Alkimos Wastewater Treatment Plant Site A (Assessment 1582)

Water Corporation

**Report and recommendations
of the Environmental Protection Authority**

**Environmental Protection Authority
Perth, Western Australia
Bulletin 1238
November 2006**

*Figure 5: Management Zones for Alkimos Ocean Outlet: Nutrients
(Note: This figure is based on the original 3.5km length of pipe, not the amended 3.7km length.)*

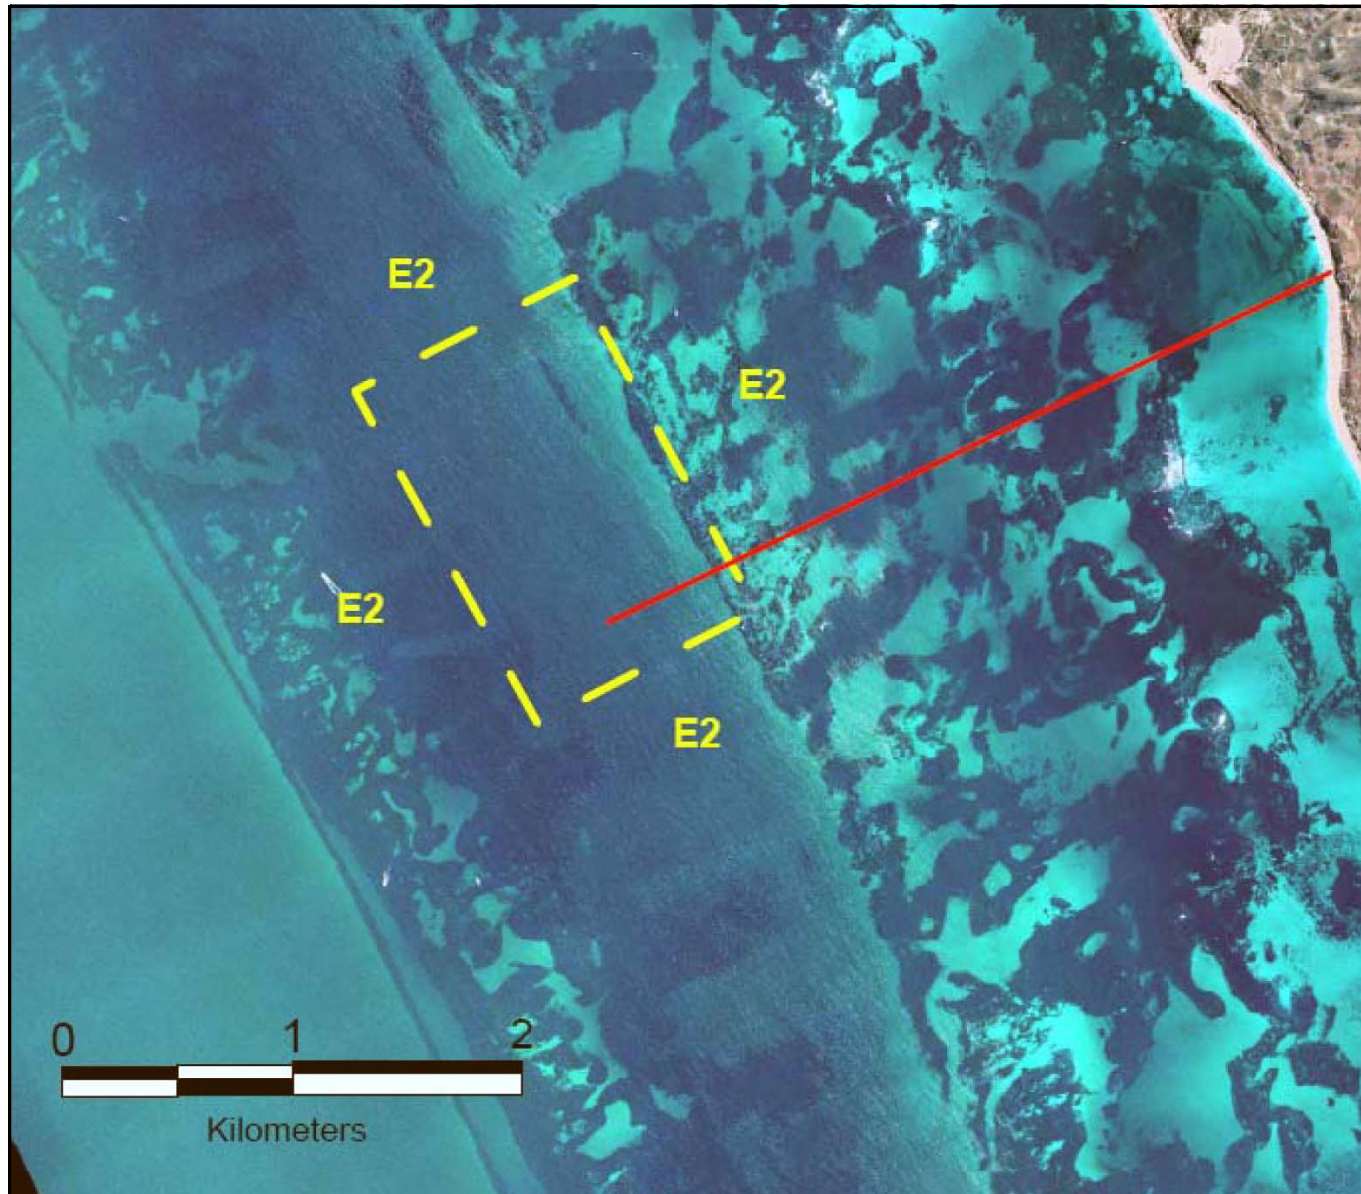
The EPA notes that the proponent has increased the length of the pipeline from 3.5km to 3.7km. The modified length of pipeline to 3.7km, which includes the 300m

diffuser, will ensure that the diffuser is placed in slightly deeper water. This would allow for greater initial dilution and provide an additional distance from and reduce any impact of the discharge plume on the shore parallel reef system inshore of the diffuser. The EPA considers that the potential impact of nutrients on the reef chain system extending inshore of the diffuser would be reduced.

- 7-2 To ensure the diffuser is located in a position to reduce the likelihood of plume impacts on high relief algal reefs immediately to the east of the outlet, the proponent shall extend the pipe length by 200m from the end of the pipe shown in Figure 4.17 of the proponent's Public Environmental Review document, Version 3, 8 November 2005. This will give a total pipe length of 3.7km from the high water mark.

Figure 6: Estimated locations of Benthic habitats along the proposed Alkimos ocean outlet pipeline route

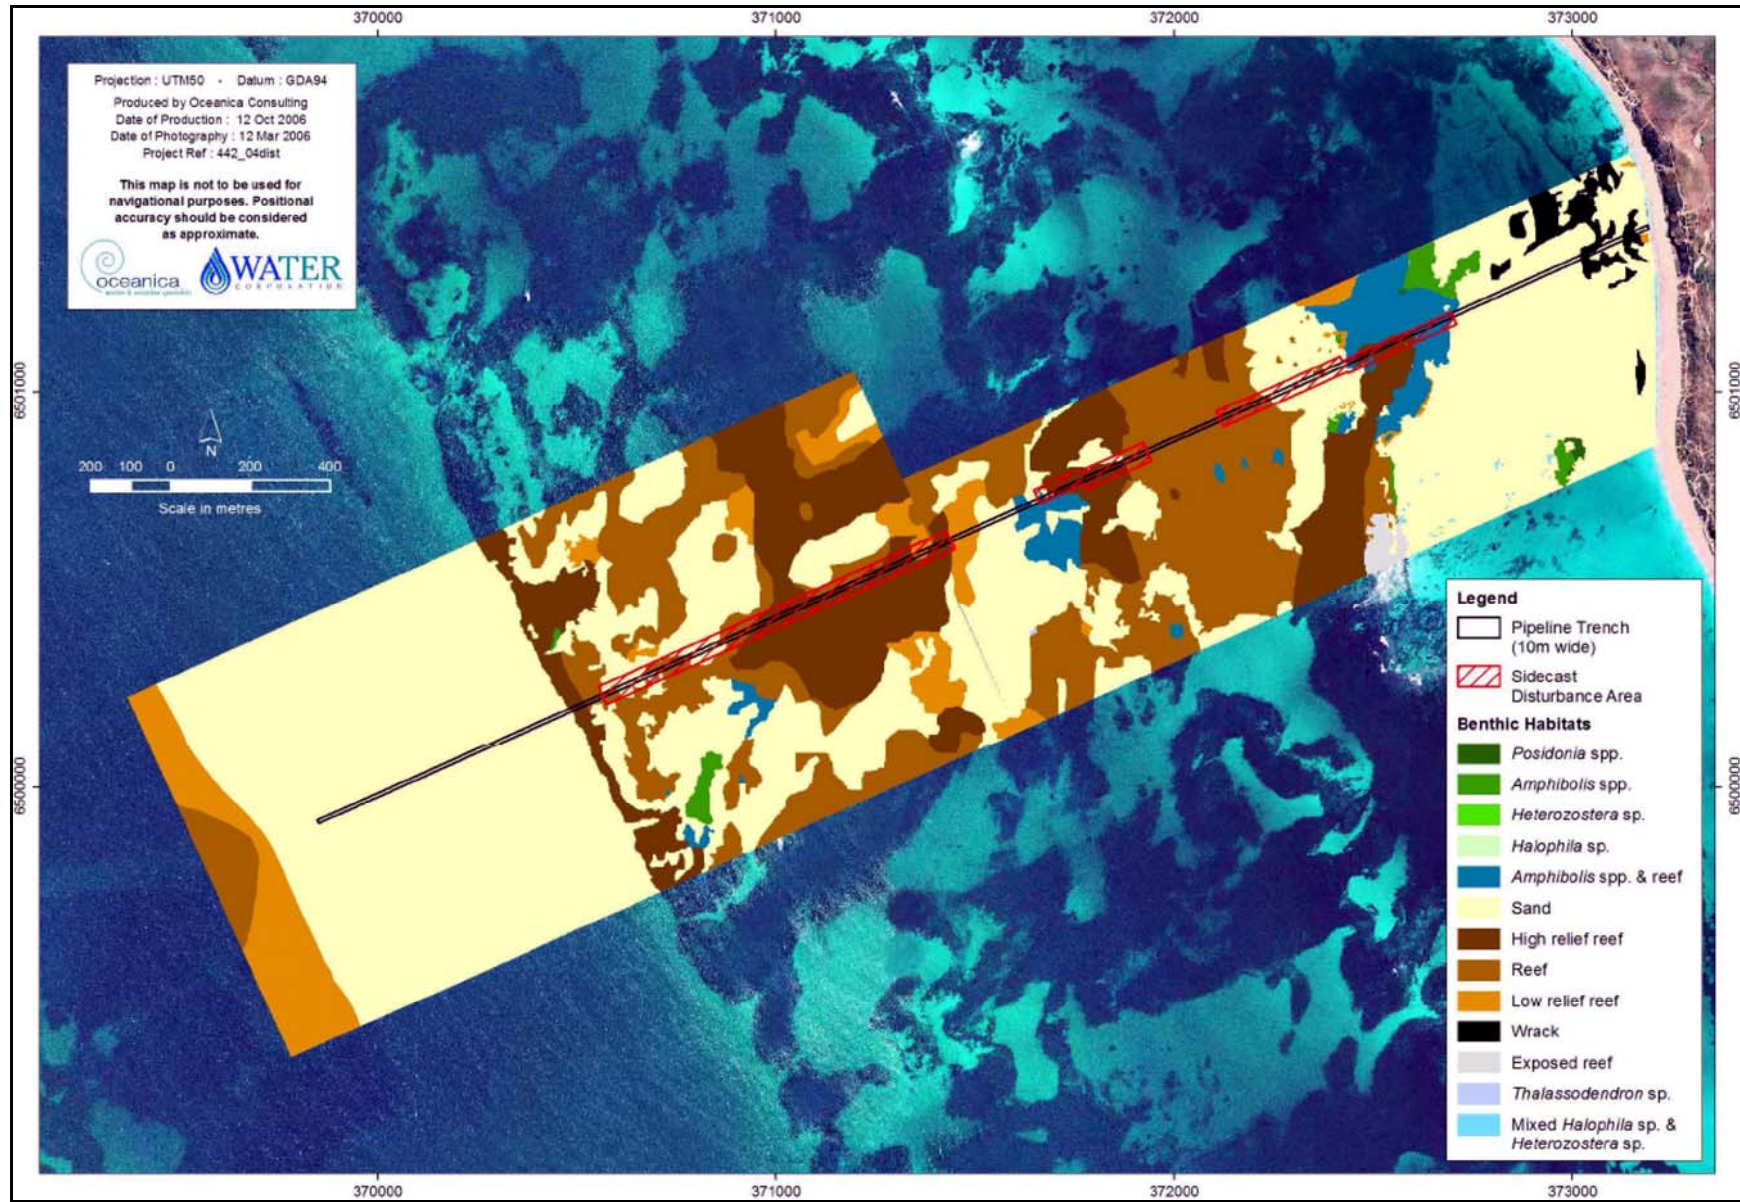
Over its entire 3.7km length, the pipeline route crosses approximately 1.4km of sand habitat and 2.3km of vegetated habitat (Figure 6). During construction a ≤ 10 m wide swathe of seabed along the pipeline route will be cleared and the piping laid on the seabed (see Appendix 5). In three sections, trenching will be required prior to laying the pipeline and the trenched material will then be side-cast (Figure 6).

Figure 2. Wind speed record for the period 28 April to 28 May 2005, data supplied by Water Corporation from Station 100 at Alkimos

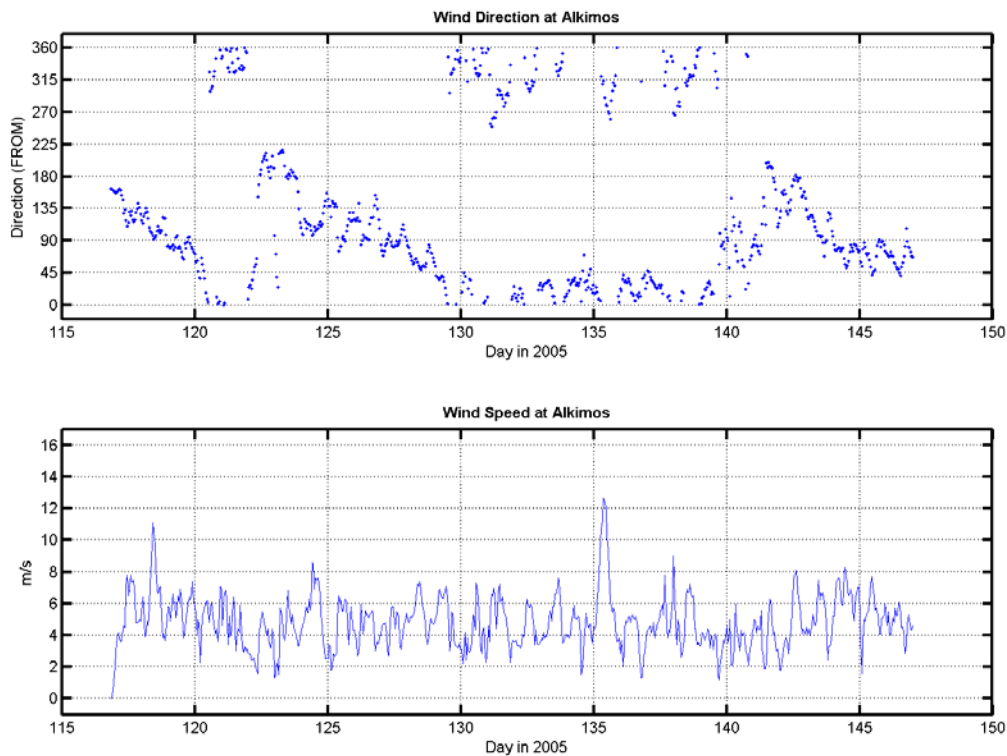
- **Validation of the model is only for late autumn/ early winter conditions – a validation for summer conditions is required.**

The wind record from Alkimos for the current meter deployment was used for model calibration. The time series of wind speed and direction is provided in Figure 3 below. The record shows two periods of high winds, corresponding to storm events in late April and mid May. It also shows a few events typical of summer conditions, with easterlies and southerly and south-south westerly winds. As a whole, the results indicated the model was responding appropriately to different wind conditions and additional validation for summer conditions is not considered necessary.

Figure 4. Time series comparison of bottom current direction and speed at Mooring A

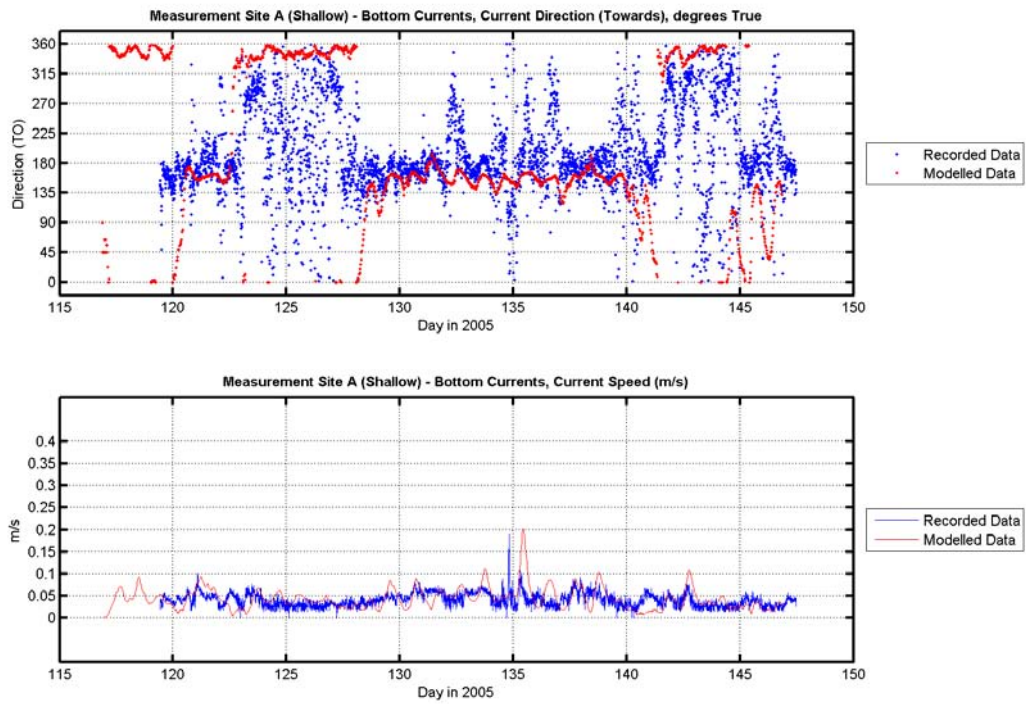
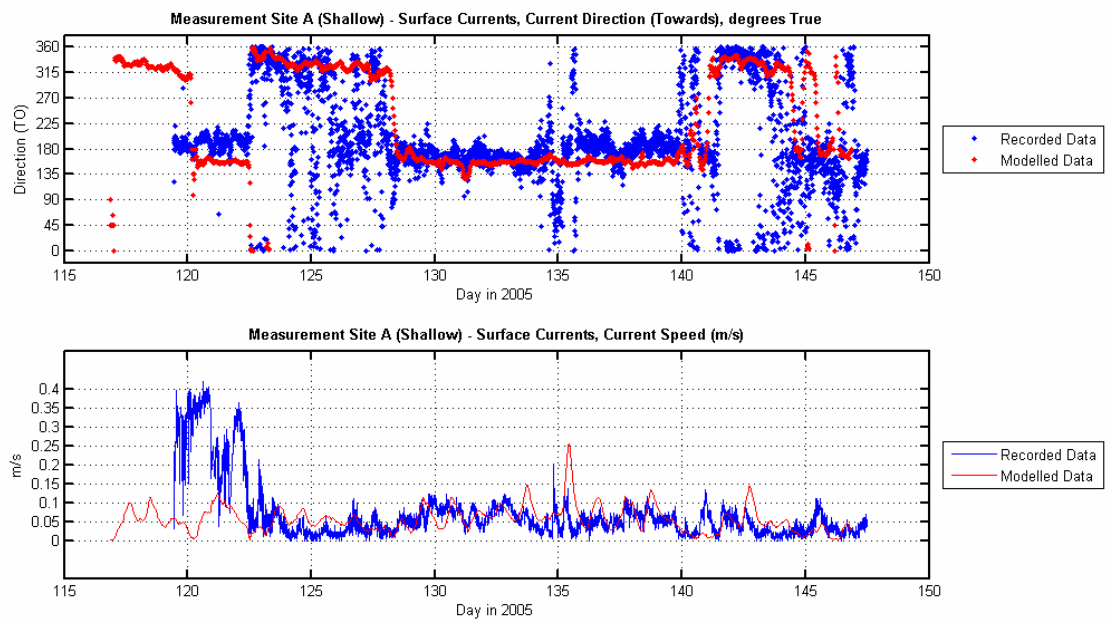
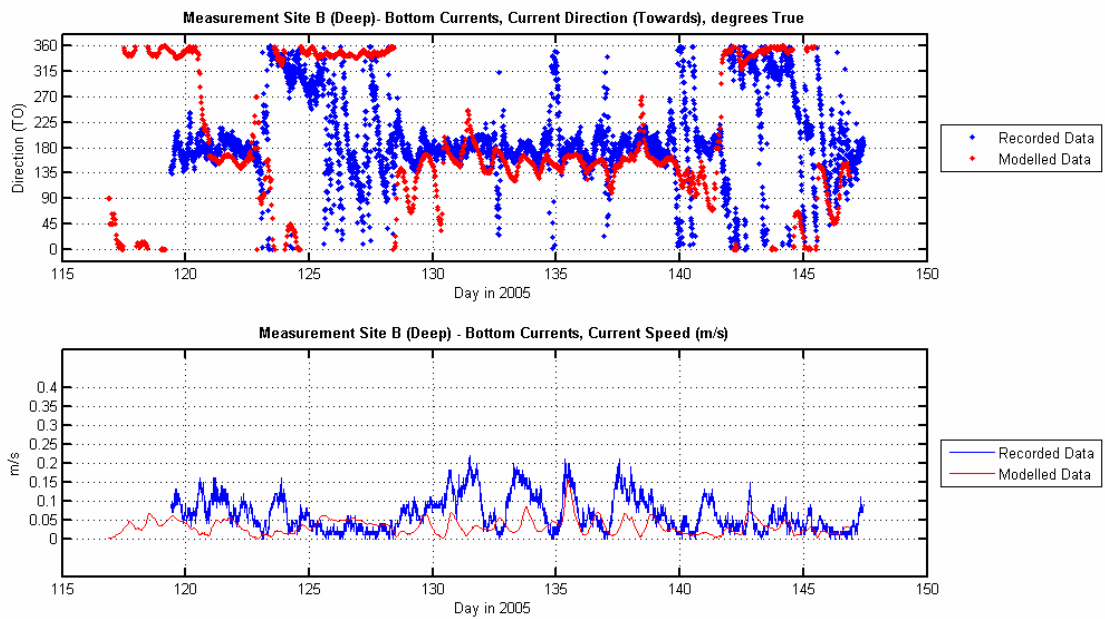
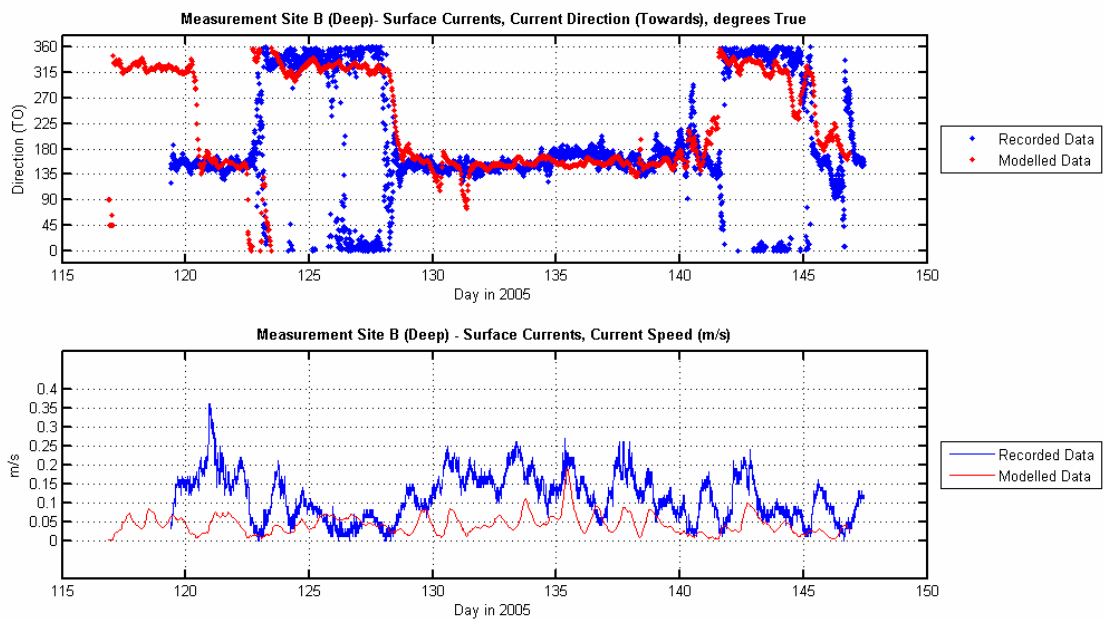
- **Exploration of the mean error, RMS error, scattergram plots and progressive vector plots are required to quantify the error between the measured and predicted model results (Submission 14).**

An analysis of the mean error and RMS error was reported in WorleyParsons (2005) to quantify the error between the measured and predicted model results as reproduced below.

Time series comparison plots of modelled and recorded near-bottom and near-surface current speeds and directions are provided for both moorings (Figure 7 to Figure 7)

The time series plots of speed and direction generally show a good match between the modelled and recorded data, particularly at Mooring A within the reef environment. However, the greatest divergence between the modelled and recorded current speeds occurs at the beginning of the calibration period in the surface record at Mooring A.
